Access Compliance Report

Public Rights-of-Way

Intersection ID: N/A	Main Street: ORCHID_BRIDGE_RD	Cross Street: PUMPERNICKEL_RD	Location: NW
ADA ID: BC040426B810	Ramp Type: Perp	Initial Pass/Fail: Fail	Overall Compliance: No
Severity Score: 13.75			
Codes/Mitigation Info/Possible Solution		Field Measurements/Component Compliance

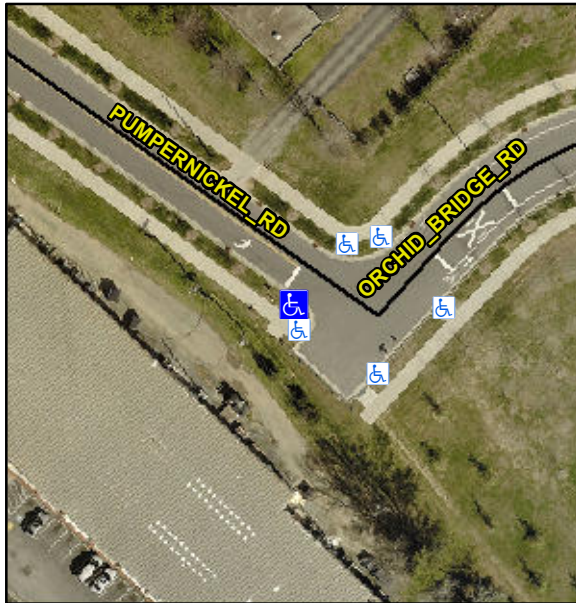
R304.2.2, R304.5.3

Compliance	Description	Data	Compliance	Description	Data
N/A	Ramp Length (in)	102.0	No	Ramp Slope (%)	8.4
Yes	Ramp Width (in)	92.0	No	Ramp XSlope (%)	3.5
N/A	Flare Type LT	N/A	N/A	Flare Type RT	N/A
N/A	Flare Slope LT (%)	N/A	N/A	Flare Slope RT (%)	N/A
N/A	Flare Traversable LT?	N/A	N/A	Flare Traversable RT?	N/A
N/A	Landing Length (in)	N/A	N/A	DWS Provided?	N/A
N/A	Landing Width (in)	N/A	N/A	DWS Contrast?	N/A
N/A	Landing Slope (%)	N/A	N/A	DWS Length (in)	N/A
N/A	Landing X Slope (%)	N/A	N/A	DWS Full Width?	N/A
N/A	Landing Curb? (Y/N)	N/A	N/A	DWS Offset (in)	N/A
N/A	Shared Landing?	N/A			
N/A	Gutter Ponding?	N/A	N/A	Gutter Slope (%)	N/A
N/A	Gutter Lip Ht (in)	N/A	N/A	Gutter X Slope (%)	N/A
N/A	Painted X Walk1?	No	N/A	Painted X Walk2?	N/A
	X Walk 1 Direction	To NE		X Walk 2 Direction	N/A
N/A	X Walk 1 Width (in)	N/A	N/A	X Walk 2 Width (in)	N/A
	X Walk 1 Slope (%)	2.5		X Walk 2 Slope (%)	N/A
	X Walk 1 X Slope (%)	1.8		X Walk 2 X Slope (%)	N/A

Remove & Replace Entire Ramp.
